APPENDIX A
AGENCY CORRESPONDENCE

ENVIRONMENTAL REVIEW

Project number: NYC EDUCATIONAL CNSTRCTN FUND / 16ECF001M

ECF East 96th Street, Manhattan
City Planning Commission Response
June 1, 2017

Two tower alternative: Put residential on top of schools at First and Second Avenues

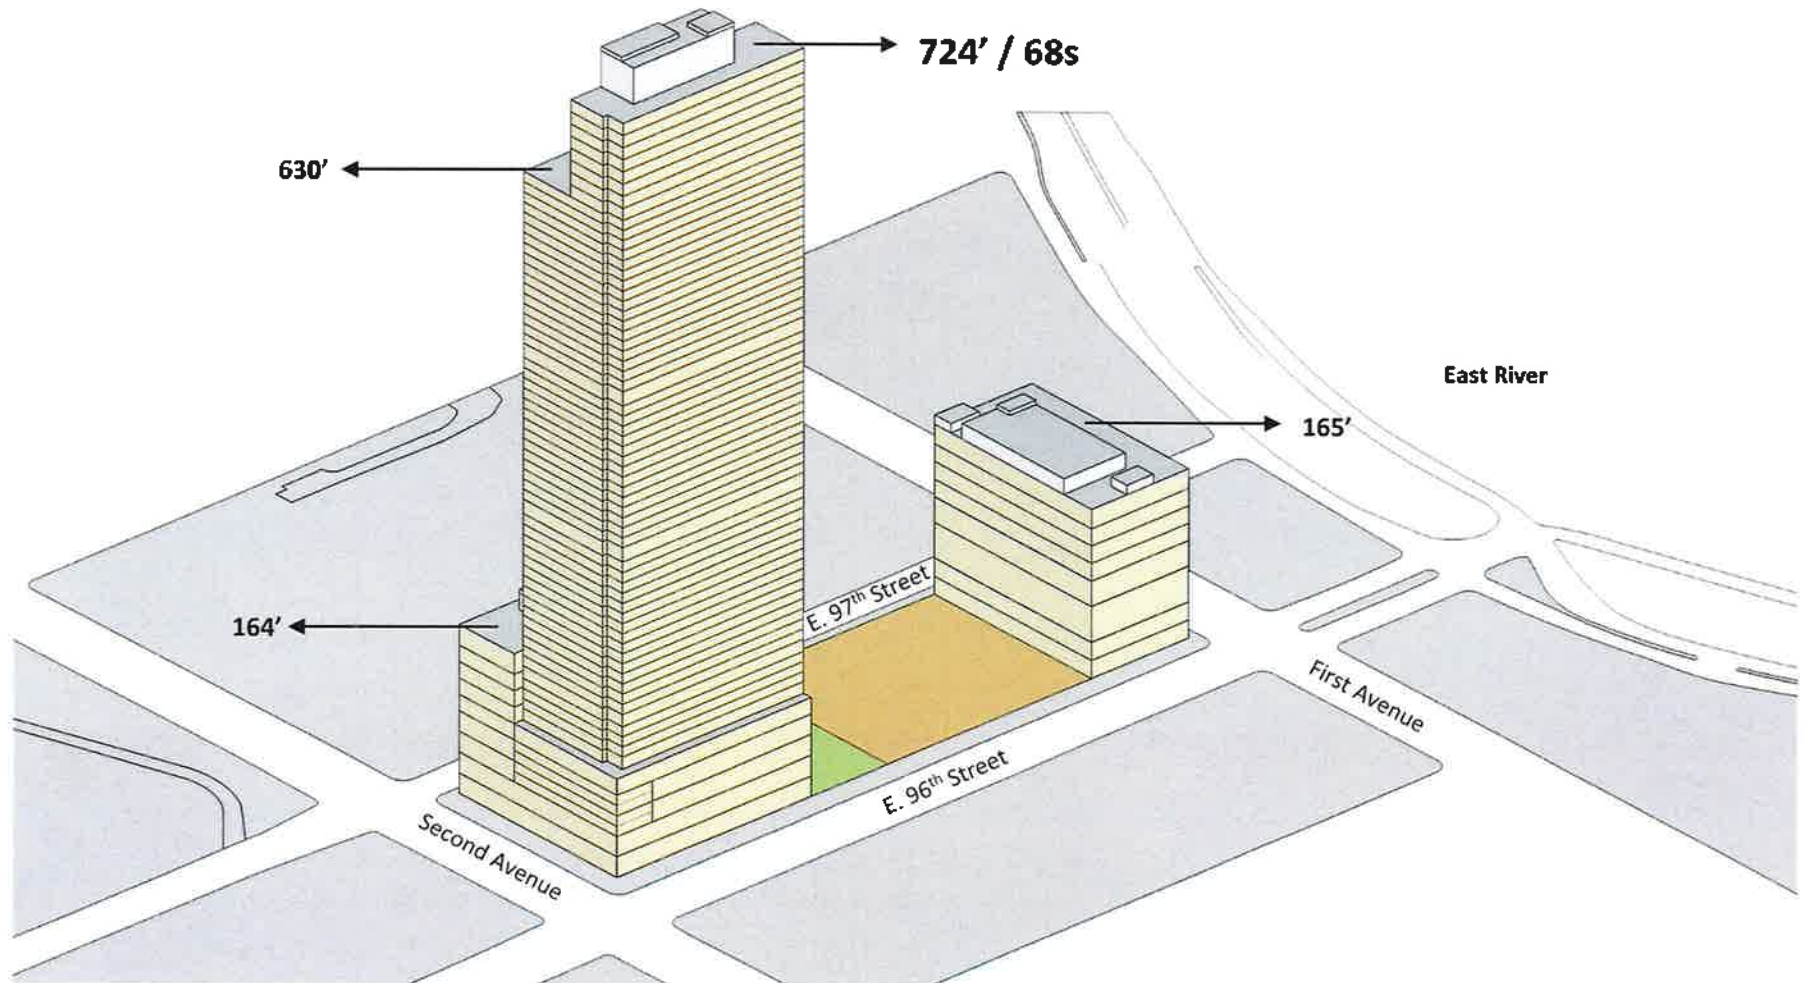
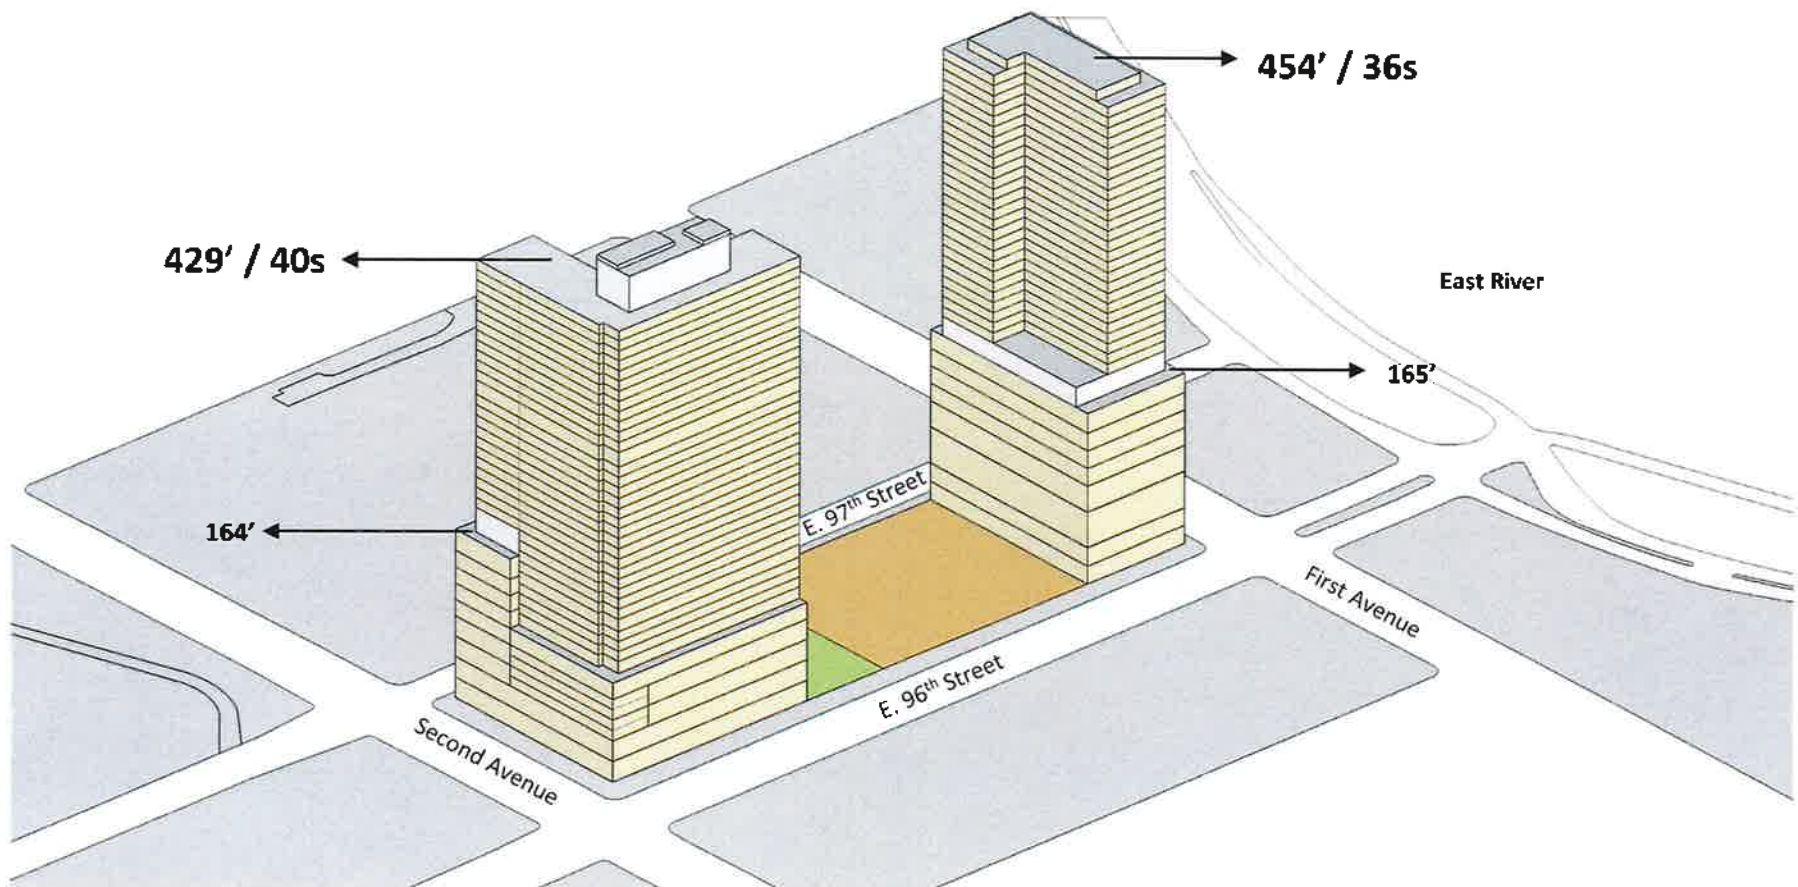
Puts core through school, but brings buildings down to about 450 feet

Two tower alternative: Put residential on top of schools at First and Second Avenues

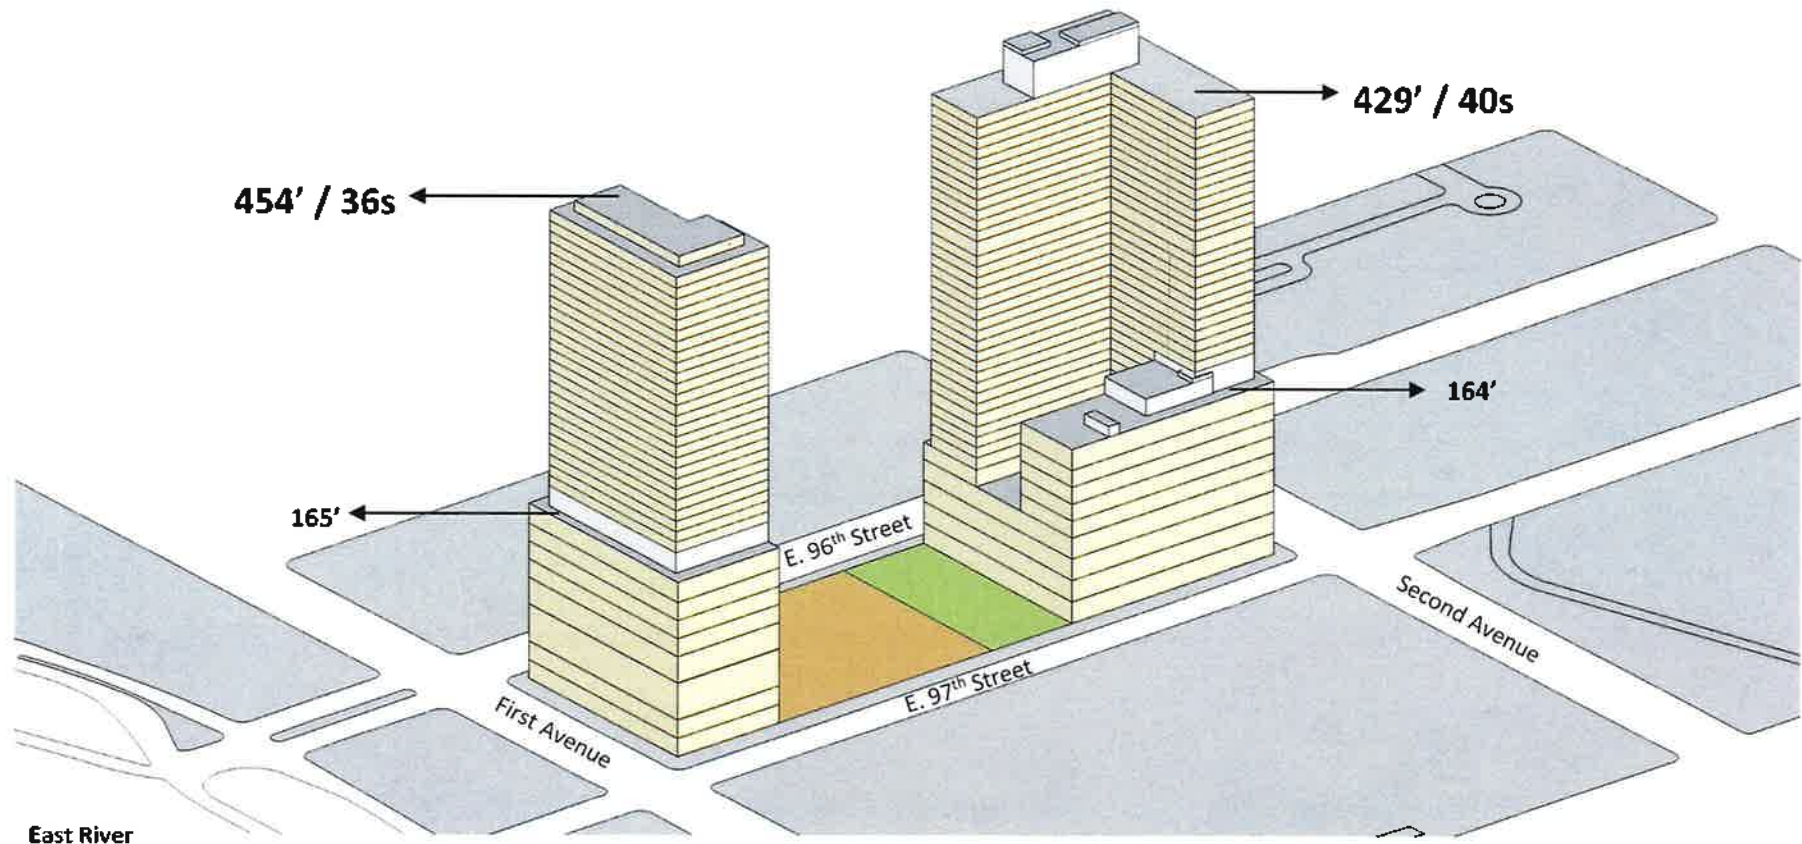
Puts core through school, but brings buildings down to about 450 feet
